# Access Compliance Report
Public Rights-of-Way
(Curb Ramps)

Intersection ID: 22474	Main Street: DENMARK_RD	Cross Street: E_HEBRON_ST	Location:	NE
ADA ID: 1EF9BC5E98D6	Ramp Type: PerpDiag	Initial Pass/Fail: Fail	Overall Compliance: No	Severity Score: 33.75

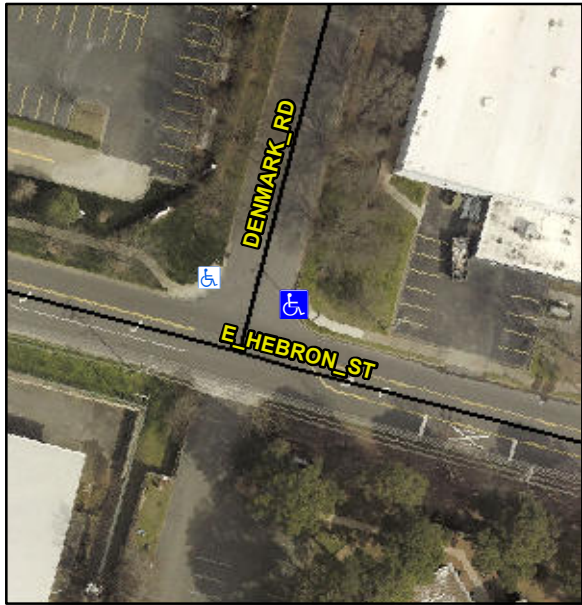
Not Found, R304.5.1, R304.2.2, R304.5.3

Compliance	Description	Data	Compliance	Description	Data
N/A	Ramp Length (in)	89.5	No	Ramp Slope (%)	8.9
No	Ramp Width (in)	43.0	No	Ramp XSlope (%)	5.6
N/A	Flare Type LT	N/A	N/A	Flare Type RT	N/A
N/A	Flare Slope LT (%)	N/A	N/A	Flare Slope RT (%)	N/A
N/A	Flare Traversable LT?	N/A	N/A	Flare Traversable RT?	N/A
N/A	Landing Length (in)	N/A	N/A	DWS Provided?	N/A
N/A	Landing Width (in)	N/A	N/A	DWS Contrast?	N/A
N/A	Landing Slope (%)	N/A	N/A	DWS Length (in)	N/A
N/A	Landing X Slope (%)	N/A	N/A	DWS Full Width?	N/A
N/A	Landing Curb? (Y/N)	N/A	N/A	DWS Offset (in)	N/A
N/A	Shared Landing?	N/A			
N/A	Gutter Ponding?	N/A	N/A	Gutter Slope (%)	N/A
N/A	Gutter Lip Ht (in)	N/A	N/A	Gutter X Slope (%)	N/A
N/A	Painted X Walk1?	No	N/A	Painted X Walk2?	No
	X Walk 1 Direction	To NW		X Walk 2 Direction	To SW
N/A	X Walk 1 Width (in)	N/A	N/A	X Walk 2 Width (in)	N/A
	X Walk 1 Slope (%)	2.2		X Walk 2 Slope (%)	7.3
	X Walk 1 X Slope (%)	4.3		X Walk 2 X Slope (%)	1.4

Remove & Replace Curb Ramp With Two New Directional Ramps or Equivalent.
